Re: Petition No. 1654 - Tunnel BESS LLC petition for a declaratory ruling pursuant to Conn. Gen. Stat. §4-176 and §16-50k, for the proposed construction, maintenance and operation of a 16.02 megawatt (MW) AC battery energy storage facility and associated equipment to replace the existing approximately 17-MW kerosene-fueled Tunnel Jet electric generating facility and associated equipment located adjacent to FirstLight Power, Inc.'s Tunnel Hydroelectric Generating Station, 72 Roosevelt Avenue Extension, Preston, Connecticut, and associated electrical interconnection

**Petition No. 1654
Tunnel BESS, LLC
16.02 MW Battery Energy Storage Facility
72 Roosevelt Avenue Extension, Preston, Connecticut**

**Interrogatories
March 5, 2025**

Canoe Portage Map

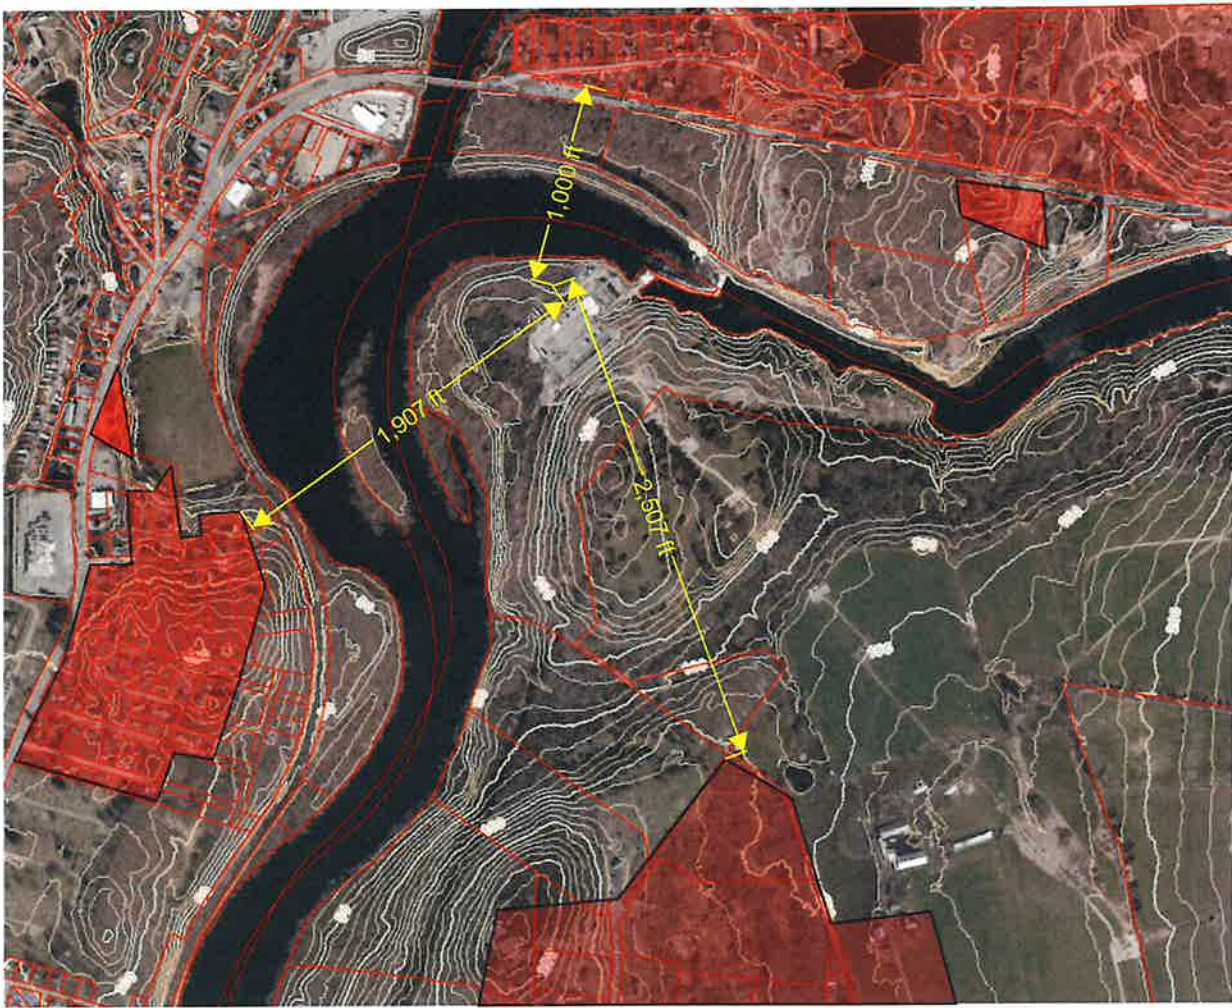
TBL Response: An existing canoe portage facility/trail is present at the site, and runs from several hundred feet upstream of the Tunnel hydrofacility dam on a wooden catwalk to the Project site, then down the roadway to a gate which allows the public to hand-carry canoes and kayaks downstream to an area safe for launching of unpowered vessels. This public access area would not be impacted by the Project. See attached Tunnel Canoe Portage Map.

Photo 20: View from closest public road looking towards site (approximately 3,000ft away)

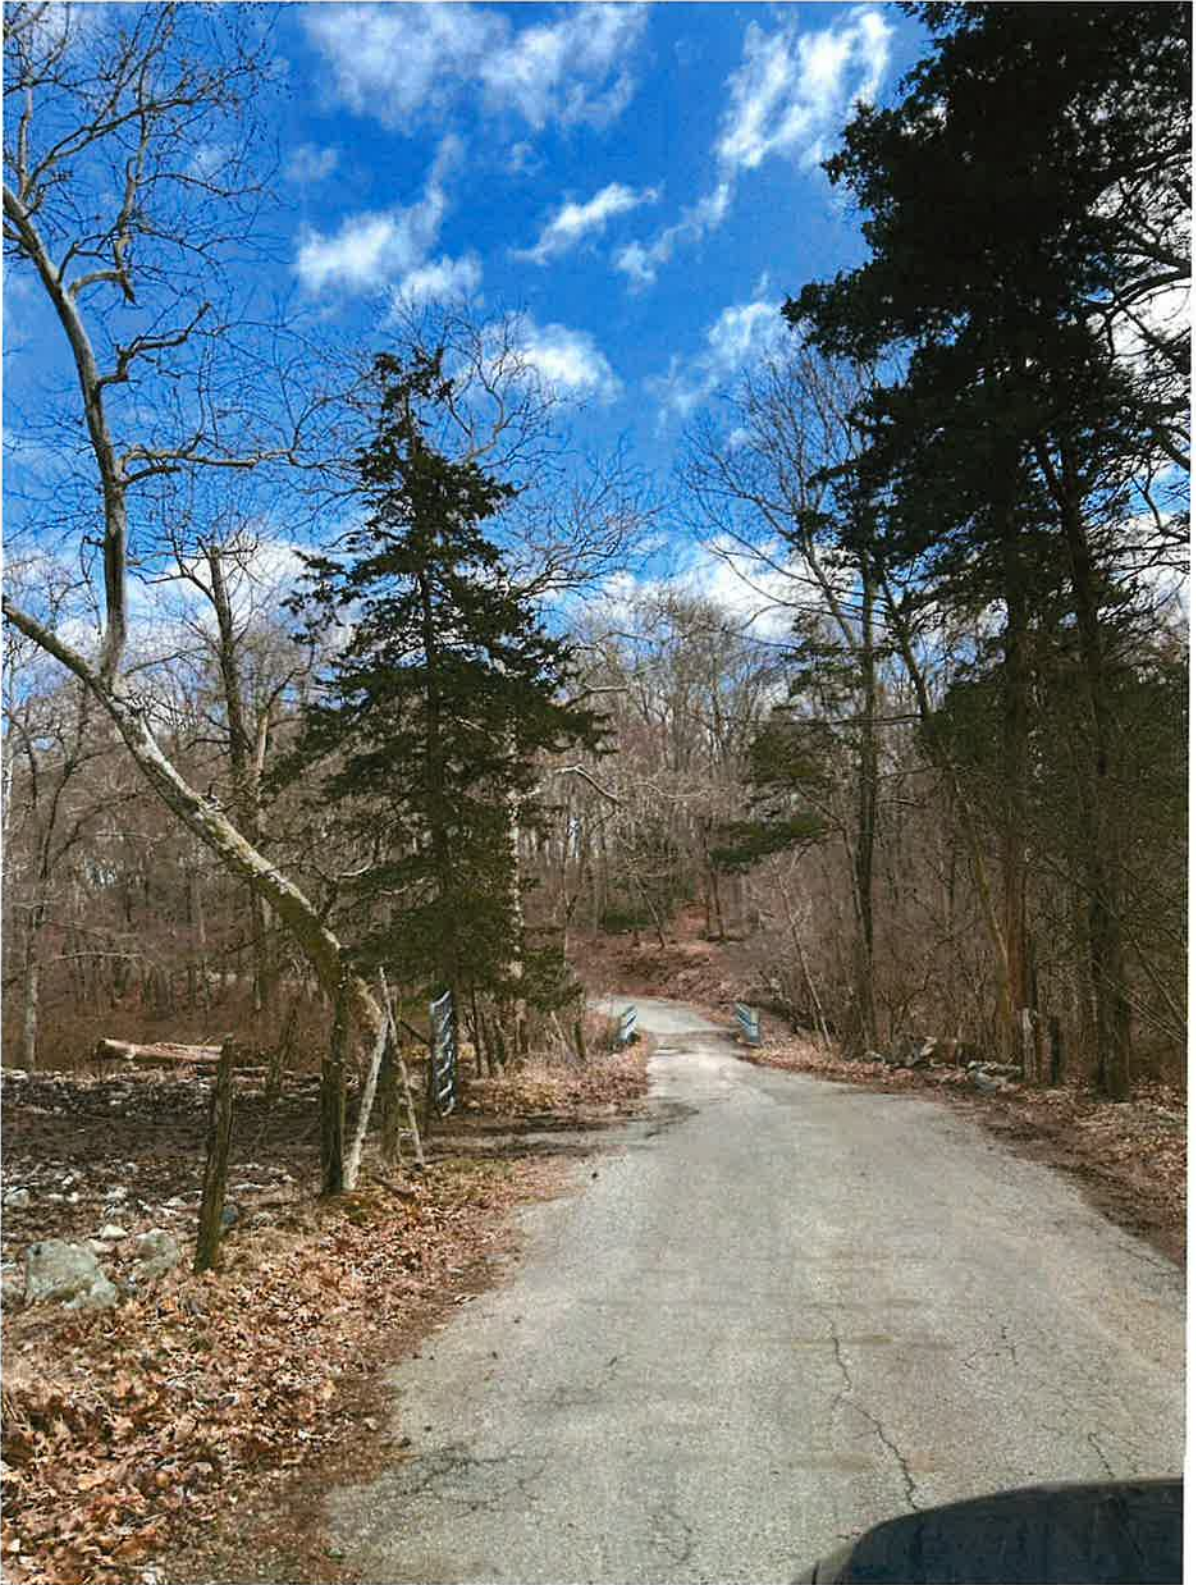
6. nearest residences;
TBL Response: Please see photo 20 of the attached photo log.
7. Site access and interior access road(s);
TBL Response: Please see photos 2, 12, and 21 of the attached photo log.
